UZBEKISTAN GAS TO LIQUID PROJECT (UZGTL)

HAZOP ACTION CLOSE-OUT REGISTER FOR MAKE-UP H2 COMPRESSOR PACKAGE

UZGTL-HDC-HSE-RP-50-0-0004

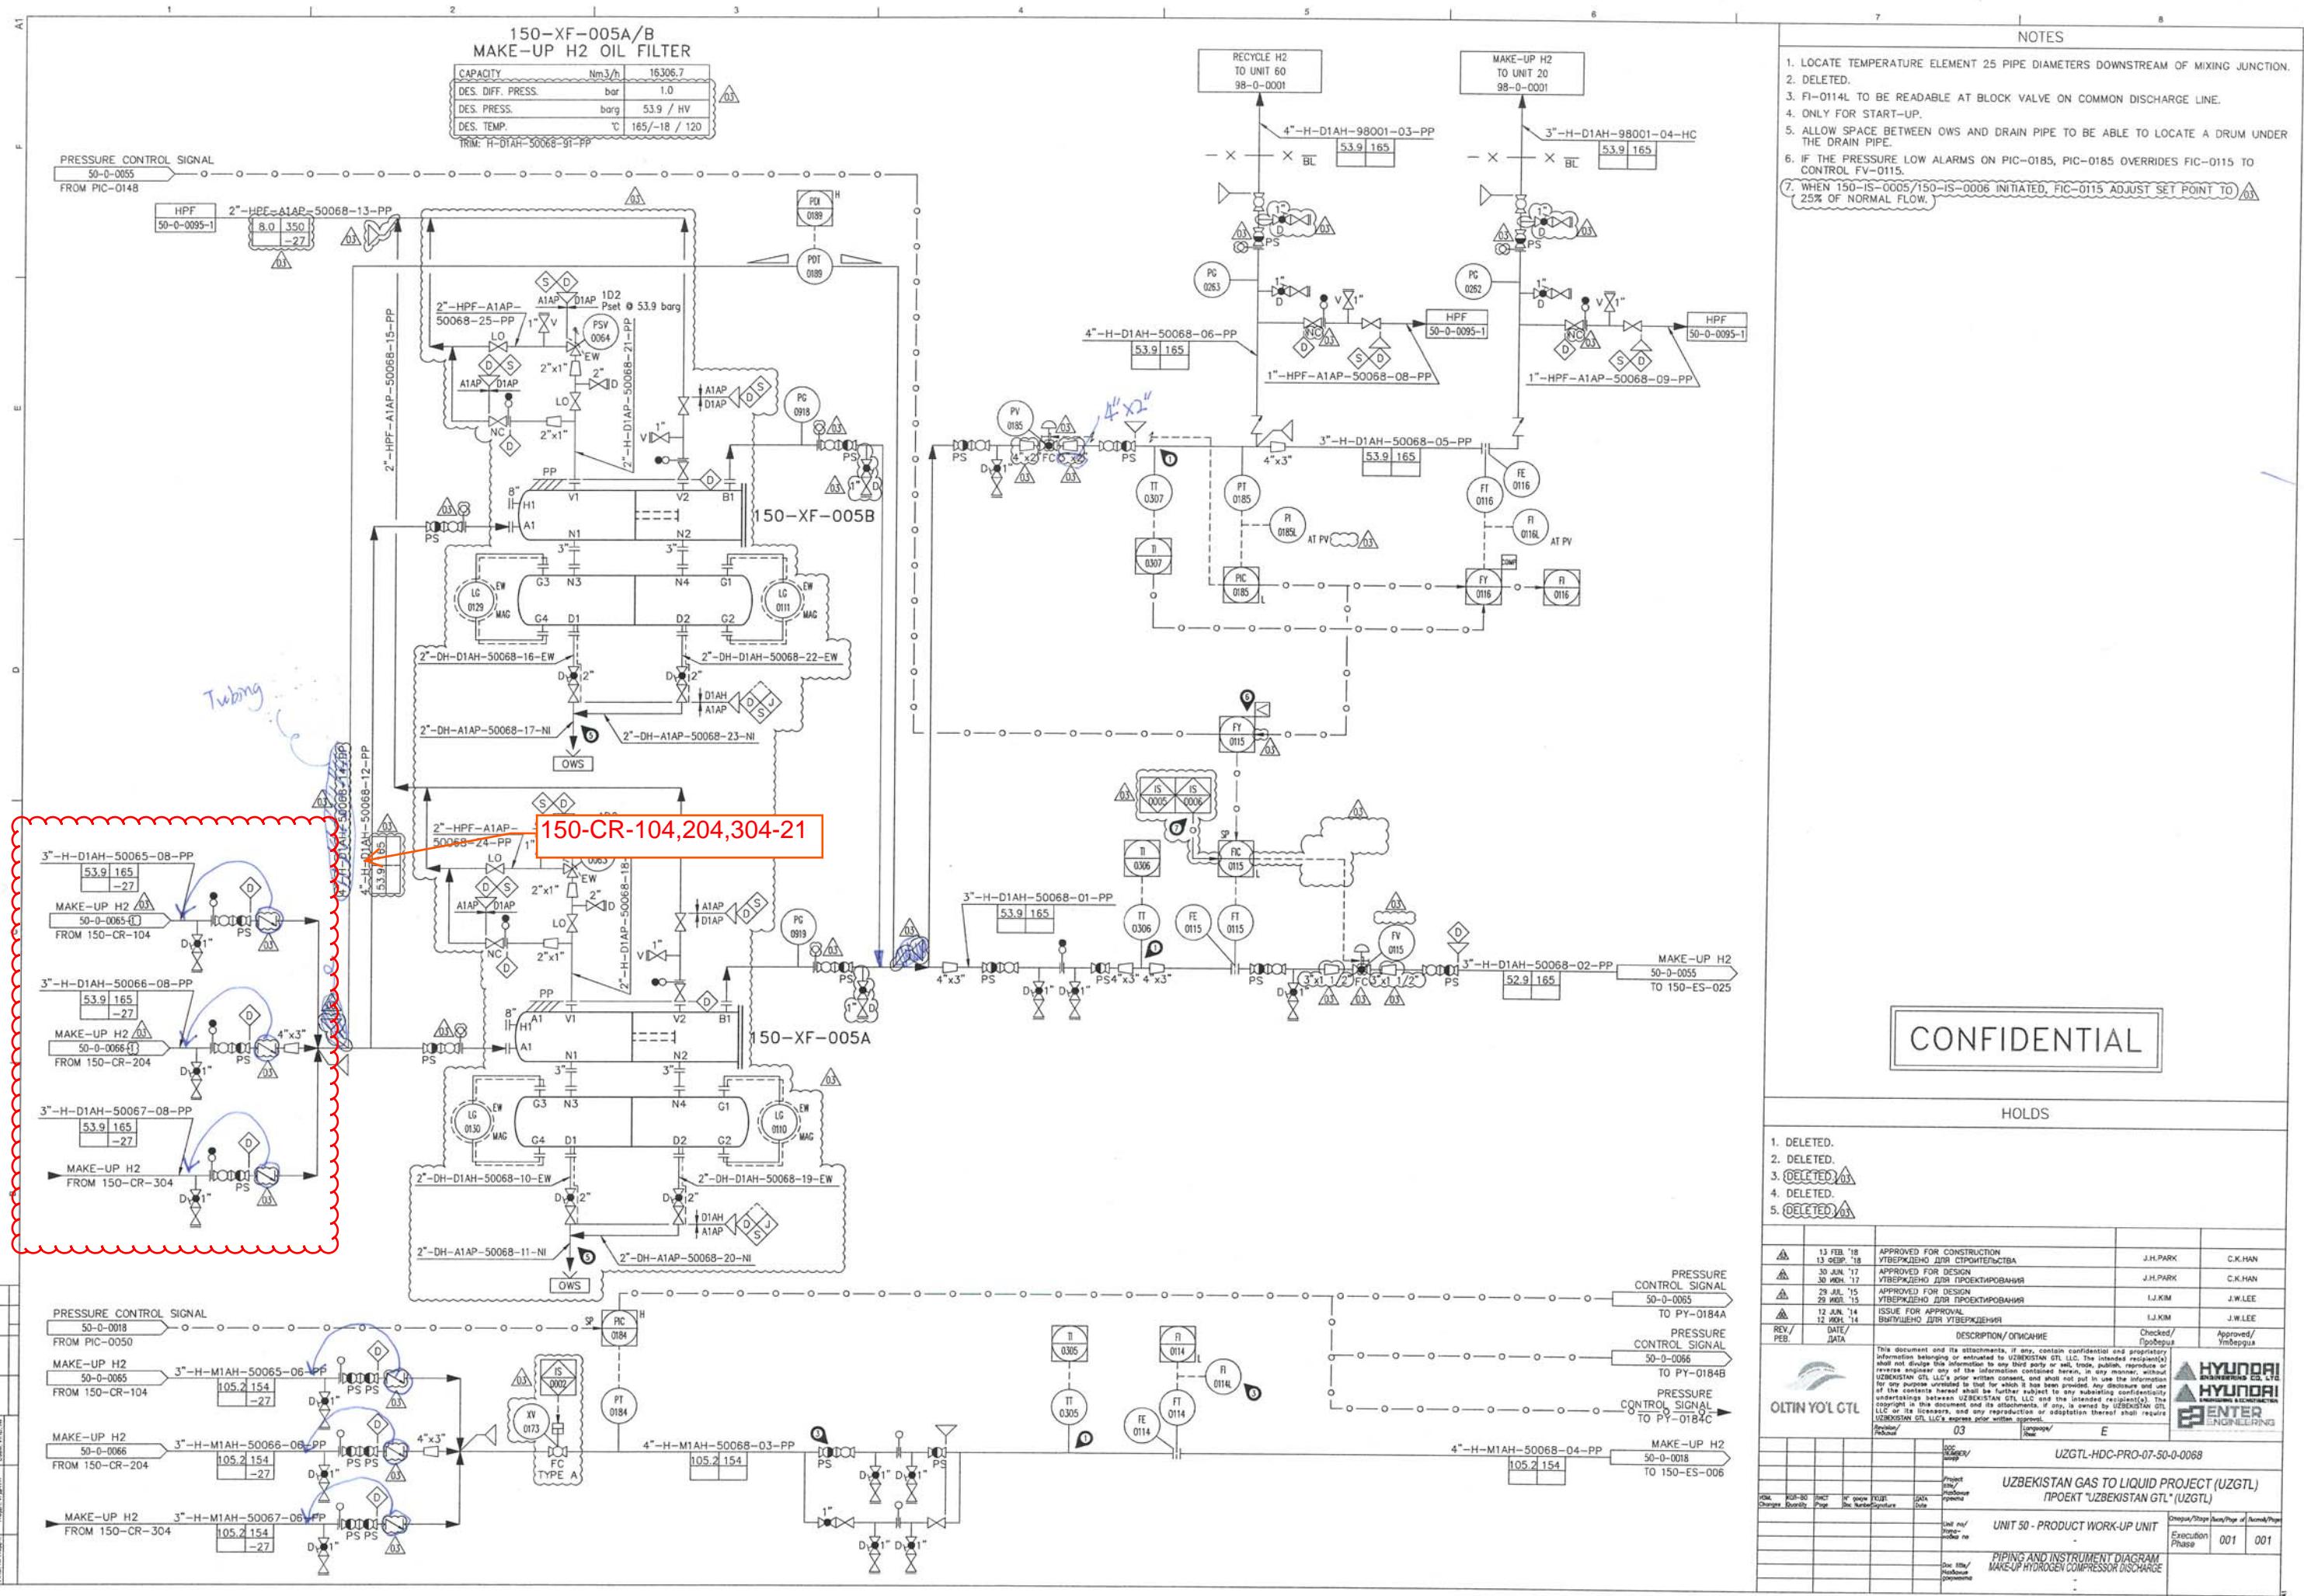
Action No.	150-CR-104/204/304-22				
Action By	PR				
Node No.	1				
Node Description	1. Compressor Process Gas / Compressor Vent & Drain / Compressor Unloader				
Cause	1.3.4. Reverse Flow of process gas from train 2 to train 1 due to train 1 Compressor trip (or vice versa)				
Consequence	1.3.4.2. Potential blow back of process gas from running Compressor discharge to stopped Compressor leading to potential overpressure				
Safeguards					
Action	Provide check valve on 2nd stage discharge of Compressor (upstream manual isolation valve on 2nd stage discharge line)				
Response	Incorporated on P&ID (50-0-0068). Check valves are provided on 2nd stage discharge of compressor. (Please refer to attached P&ID, UZGTL-HDC-PRO-07-50-0-0068)				
CONTRACTOR			OWNER		
Position	Signature	Date	Position	Signature	Date
Process Engineer	<u>B.M.Hwang</u> 	10-Apr-2018		_____
